ASSESSMENT REPORT

Cobaki Lakes Residential Community Development Concept Approval MP 06_0316 (MOD 9)

Figure 3: Proposed Swamp Sclerophyll Forest EEC Offsets (source: Amended Site Revegetation and Regeneration Plan (JWA, 2017))

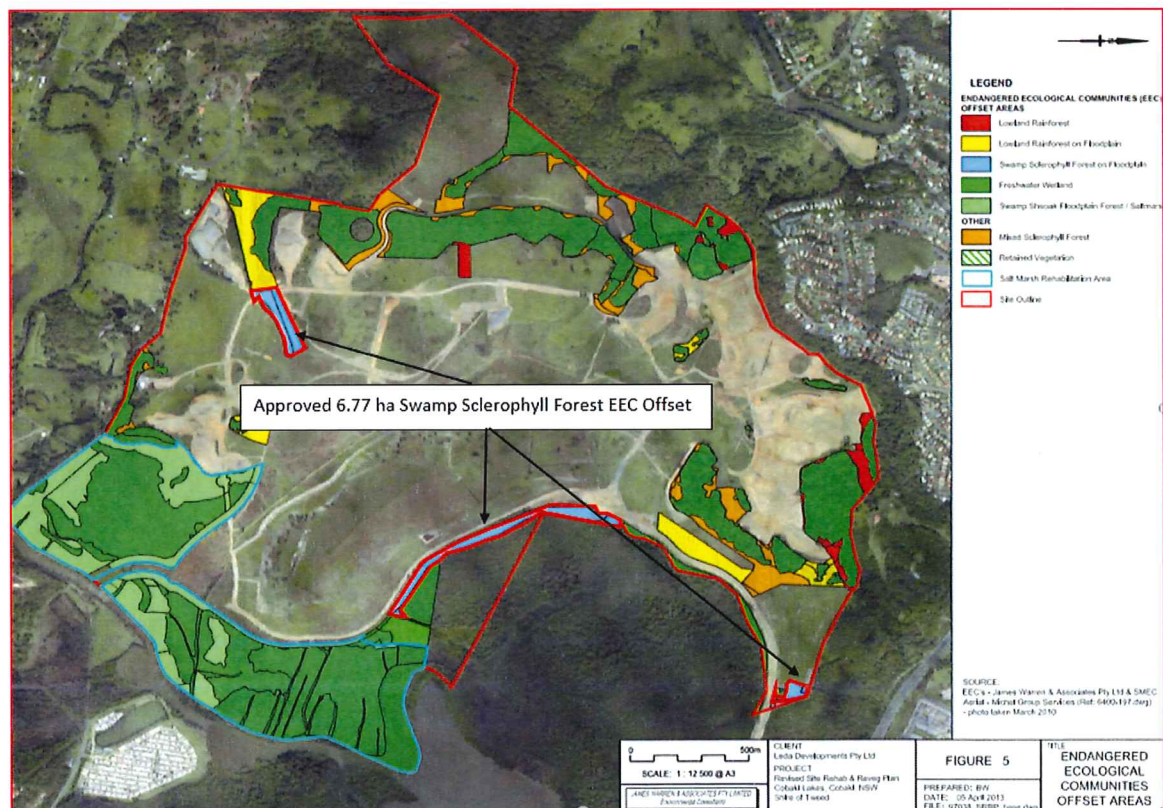
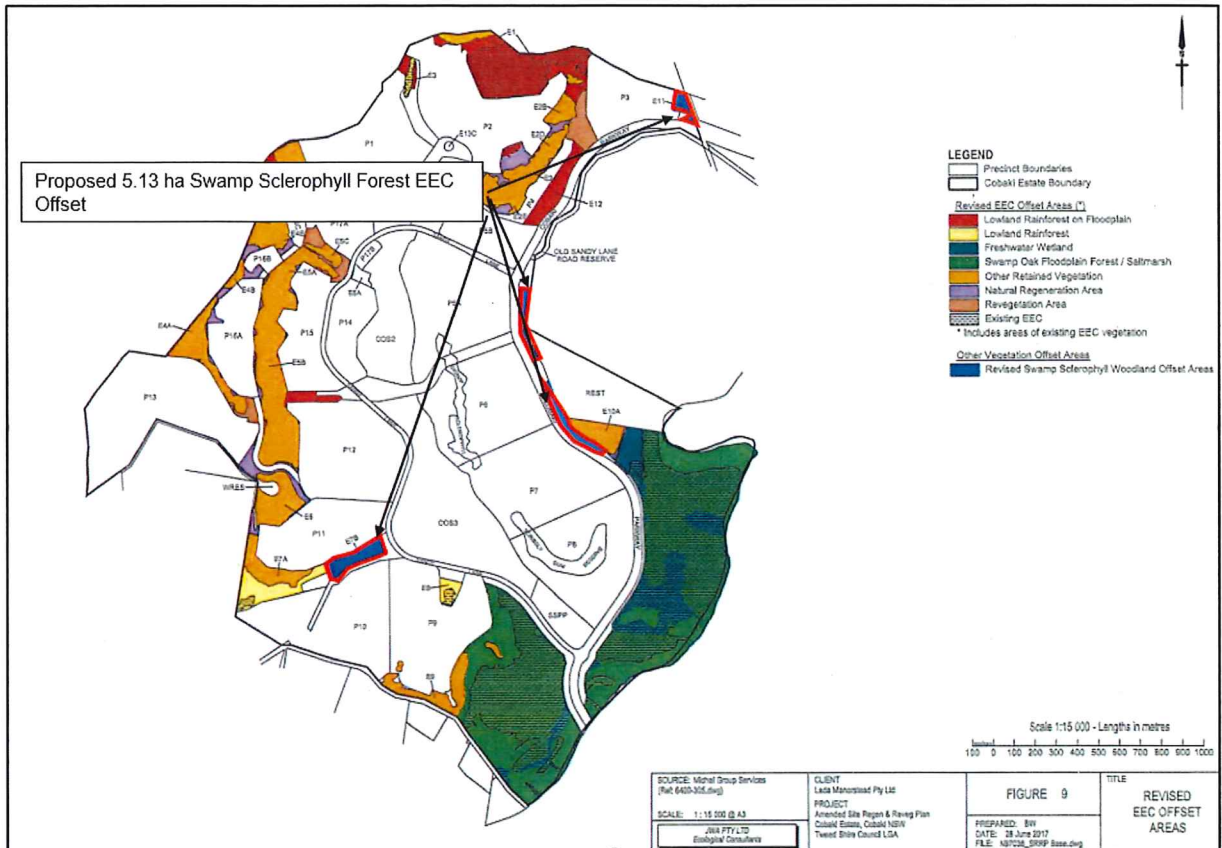
- the proposal would decrease the SSF EEC offsets from 22.7 ha (6.77 ha on-site and 16 ha offsite) to 14 ha;
- the shortfall in the on-site offset area should be addressed by expanding the approved SSF

- the proposal would decrease the total offsets required for the clearing of 3.8 ha of SSF EEC from 22.7 ha (6.77 ha on-site and 16 ha offsite) to approximately 14 ha;

- the proposed offsets for the SSF EEC are inconsistent with the recommendations of the Umwelt review;
- the management regime and development activity undertaken in and around the SSF EEC since the determination of the Concept Plan may have reduced the ecological integrity of this EEC. Accordingly, the vegetation surveys undertaken in 2016 should not be relied upon to determine the ecosystem and species credits required to offset the SSF EEC;

Based on the Umwelt methodology and the reduced on-site offset of 5.13 ha (equivalent to 33 ecosystem credits) the proposal would require 159 ecosystem credits to ensure a total of 192 ecosystem credits will be provided to offset the clearing of 3.8 ha of SSF EEC. The Department has recommended modifications to Term C19(2) to ensure this occurs.

Figure 5: Proposed Areas of Lowland Rainforest on Floodplain EEC (source: Revised Site Revegetation and Regeneration Plan (JWA, 2017))

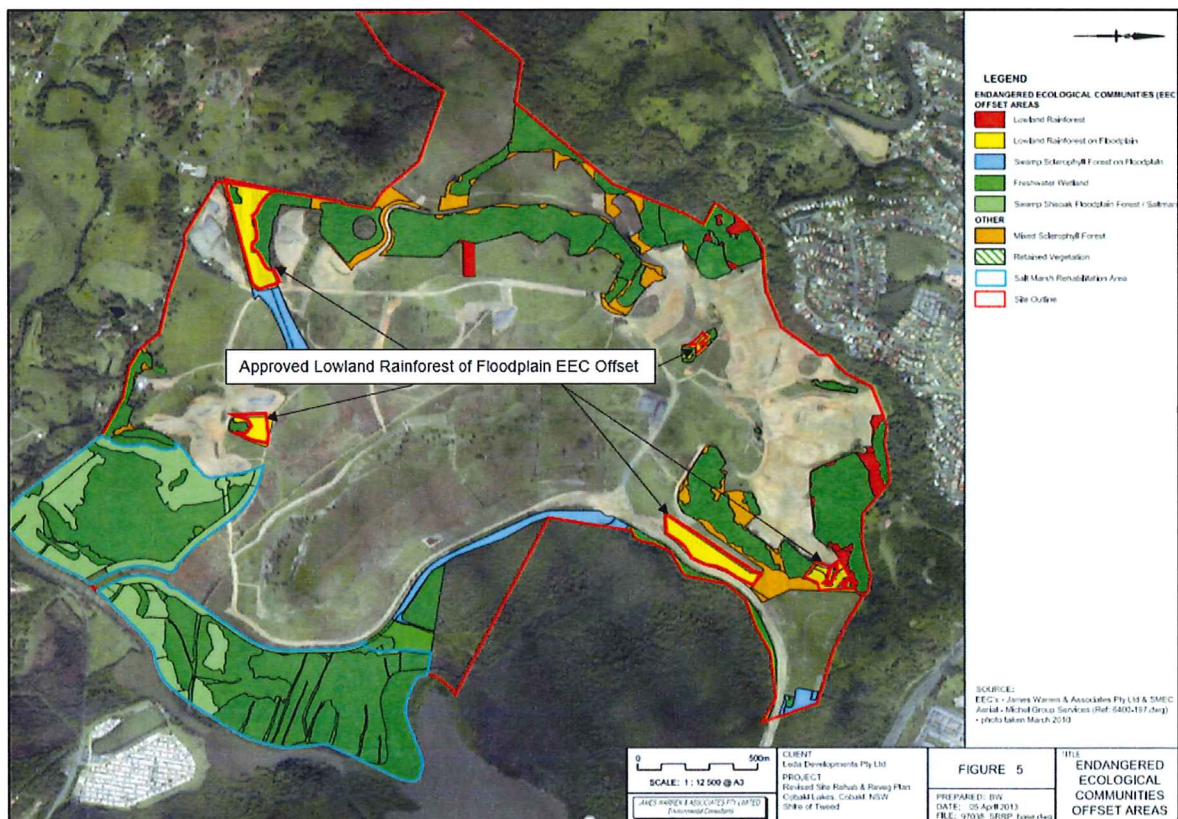
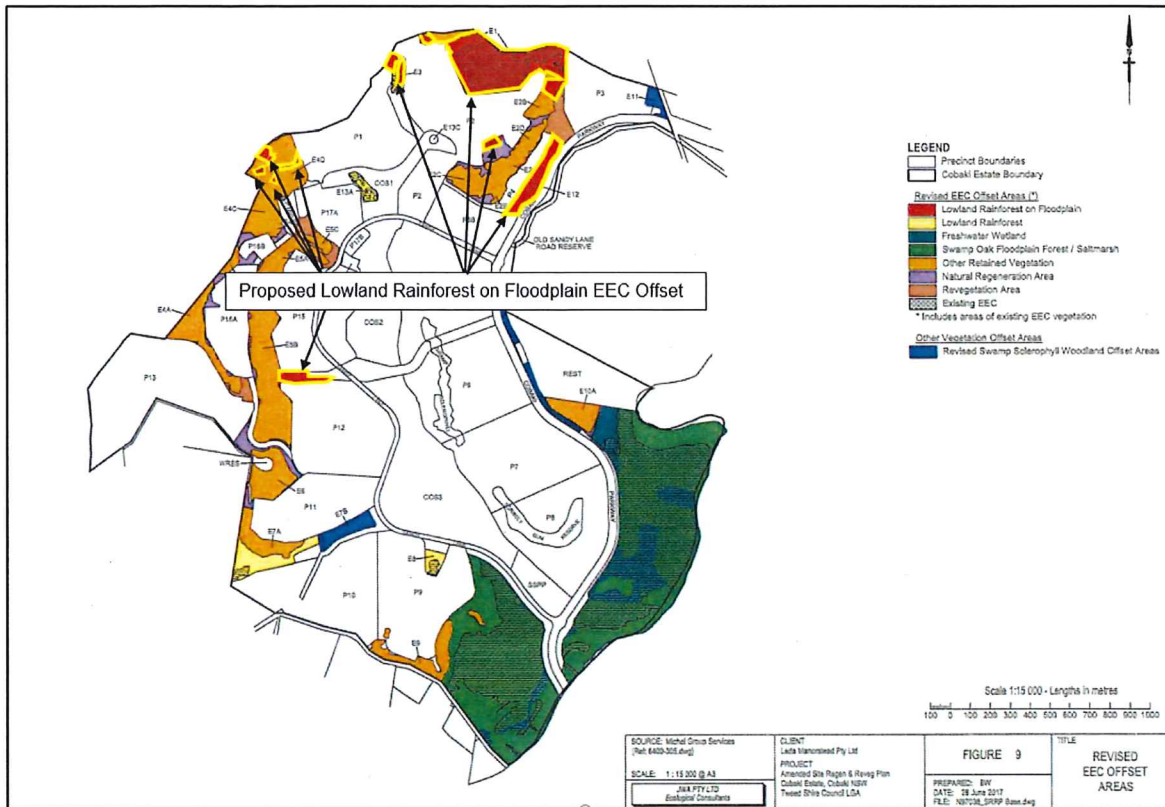
The Department notes both the Council and the OEH advised insufficient justification has been provided to support the proposed reclassification of the Lowland Rainforest on Floodplain EEC and the proposed reduction in the on-site offset area for the Lowland Rainforest communities.

The Department agrees with the ELA review that there is insufficient information to support the proposed reclassification of the Lowland Rainforest on Floodplain EEC. Notwithstanding, the Department notes that as both Lowland Rainforest communities are comprised of the same PCTs, the offset requirements are the same regardless of their classification.

The Department has reviewed the proposed 0.34 ha reduction in the on-site offset areas for the Lowland Rainforest on Floodplain EEC and concludes the proposal is acceptable as the offset areas identified in the Amended Site Regeneration and Revegetation Plan would continue to generate sufficient ecosystem credits to offset the removal of this vegetation.
